CITY OF DOVER

PLANNING TECHNICAL REVIEW COMMITTEE –AGENDA

1. 10:30 AM – 11:15 AM: Site Review for JSR, LLC., Assessor's Map D, Lots 11-5 & 11-5SND, zoned IT & Wetlands Protection Districts located at Quality Way and Venture Drive. (Proposal is for construction of a 10,080 s.f. Contractor Storage Bay/Office facility consisting of four (4) separate bays with office space.) A CUP and LLA will also appear before the Planning Board. (P22-55/SITE-2022-0011) [*Previously heard on August 11, 2022*]

Re: Site Plan Review
Berry Surveying & Engineering
JSR, LLC
Venture Drive & Quality Way
Tax Map D, Lots 11-5 & 11-5SND
Dover File #P22-55

GRADING & DRAINAGE PLAN

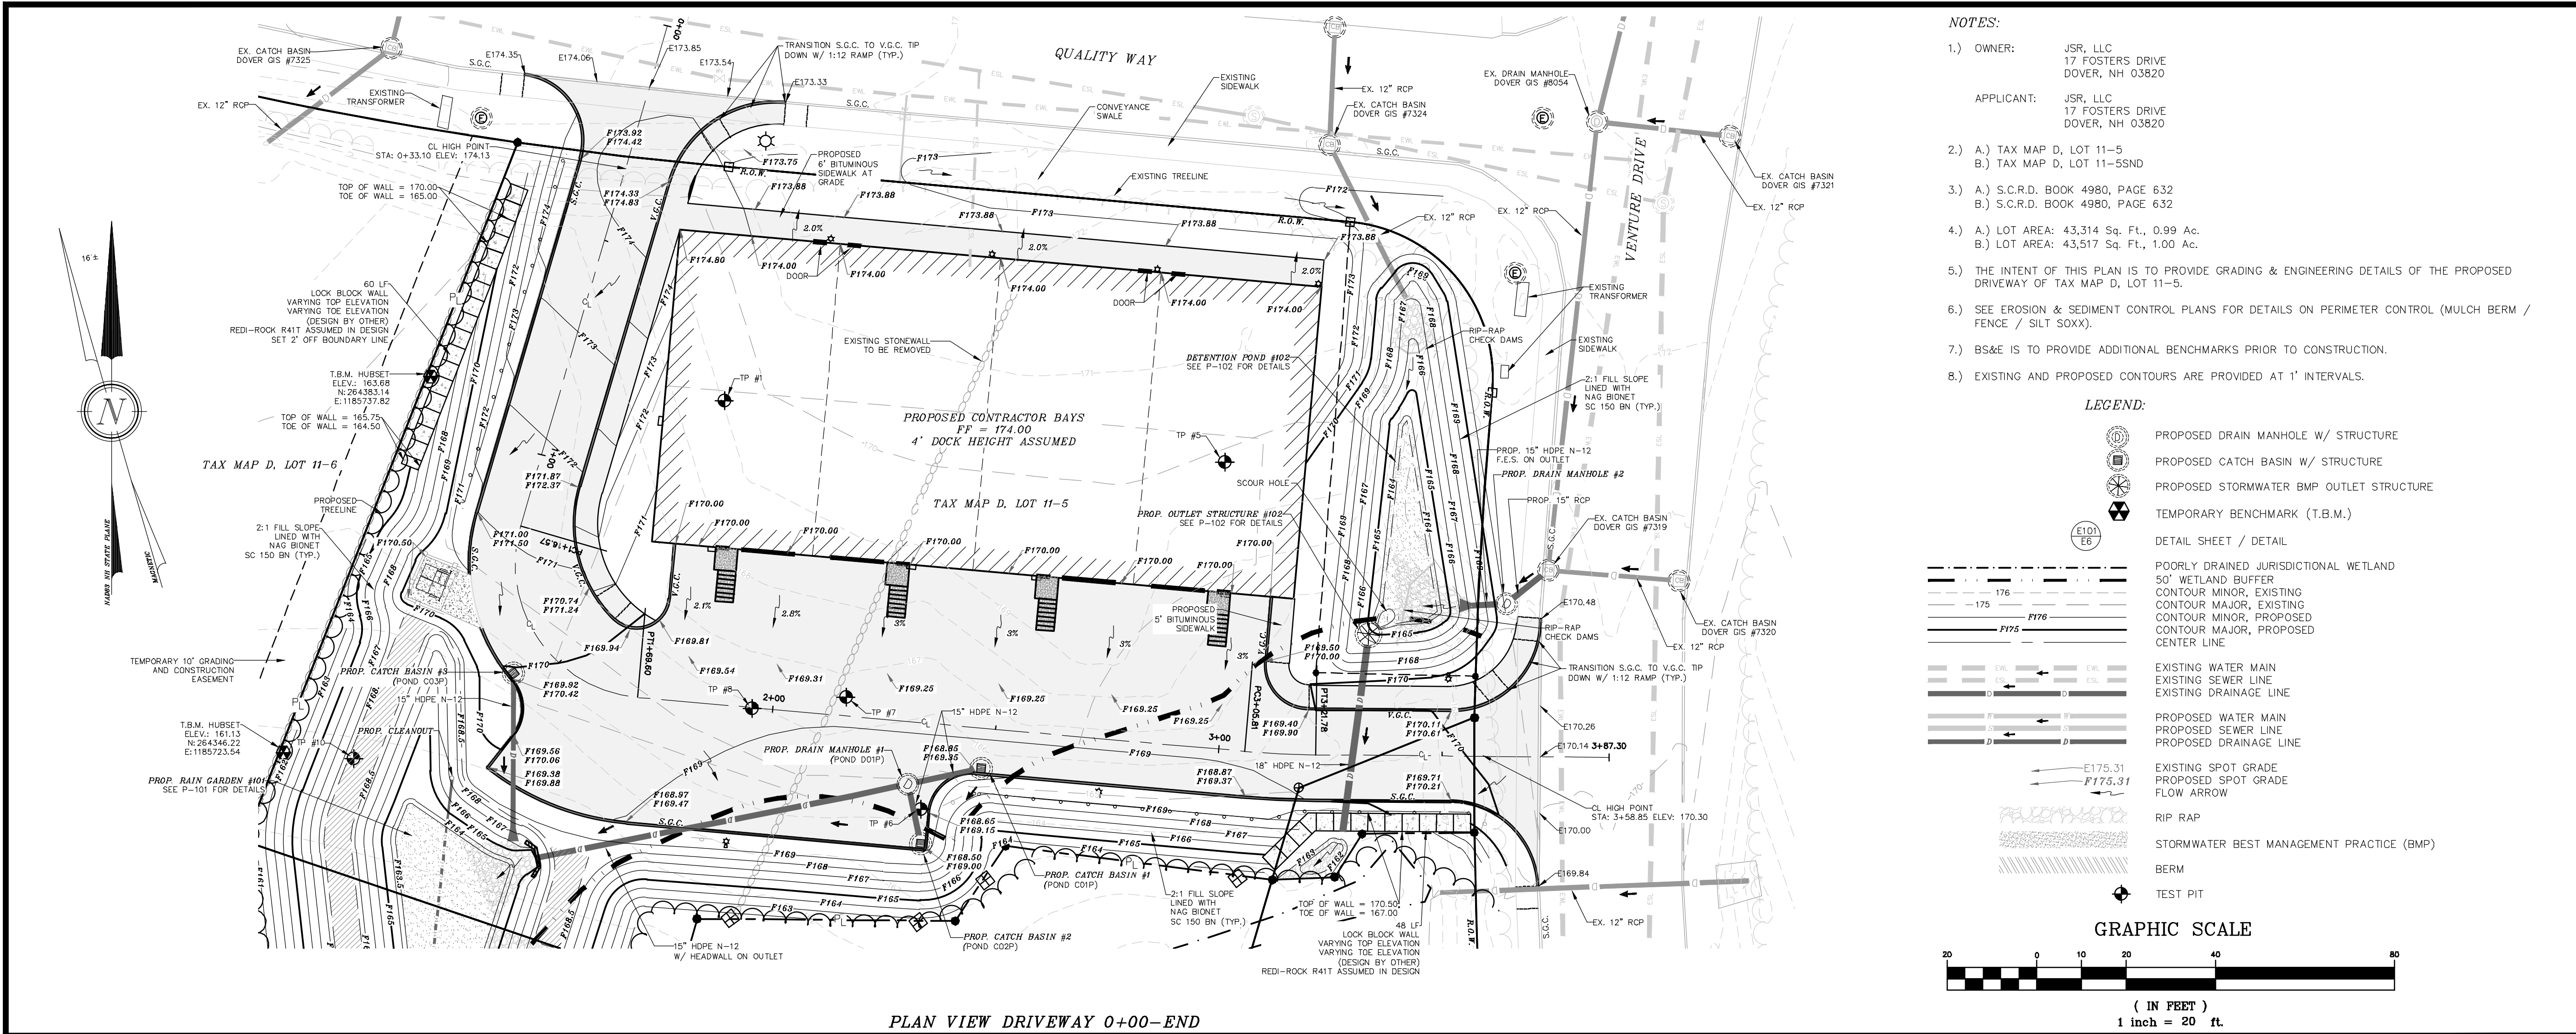
5. Sheet 6: It is recommended to make the two catch basins east of Station 2+00 off-line catch basins for pre- treatment of stormwater.
These structures of been made off-line structures. See Grading Plans, sheets #7 & 8.

6. Sheet 7: It is recommended to raise the grade of both driveway entrances to prevent water on Quality Way and Venture Way from entering the property.
Please find revised profiles and grading. See Grading Plans, sheets #7 & 8.

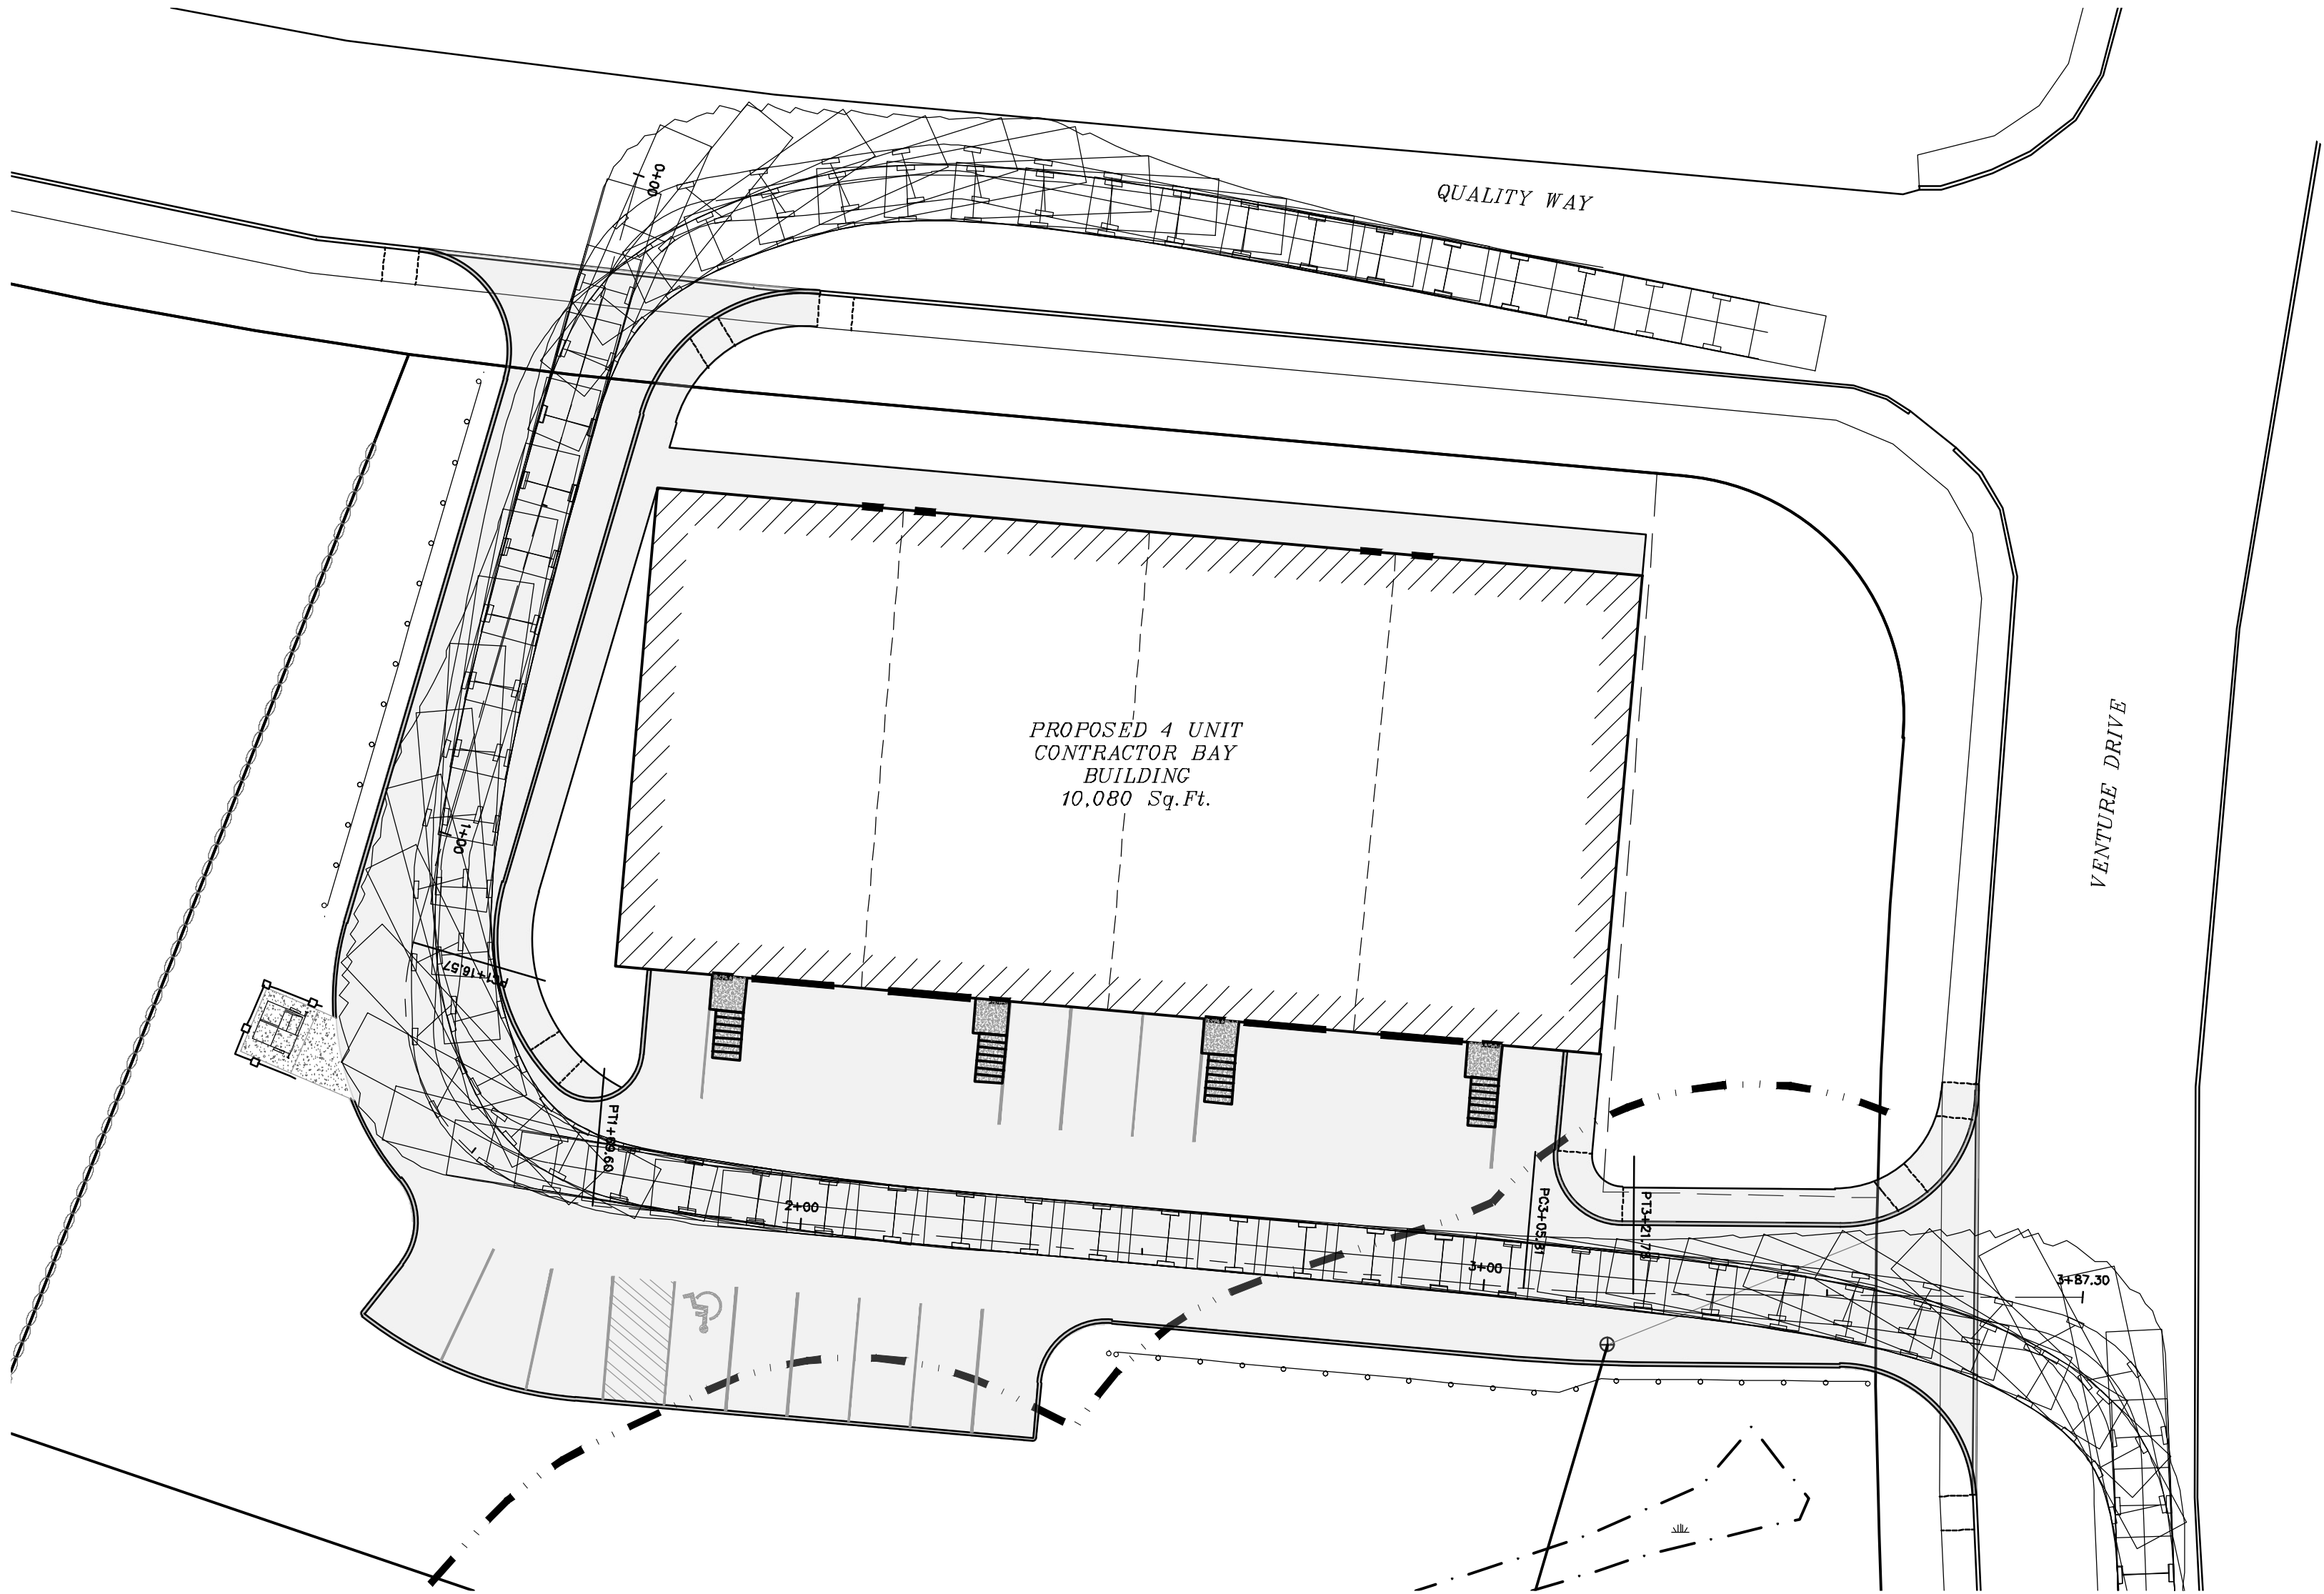
17. Sheet 26: Provide profile view of the fire truck including dimensions.
Truck has been added to the plan. See Truck Turning, sheet #27.
18. General Comment: Provide plan or other legal description showing proposed modifications to the existing drainage easement. Plan should indicate that the maintenance of the proposed detention basin will be the responsibility of the Applicant/Property Owner as indicated in the Narrative.
This has been done graphically and this note is now added to the Easement Plan, sheet #5 as note #9.
19. Drainage Report: Please provide a BMP worksheet and storage tables for detention basin #102.
Please find revised Drainage binder.
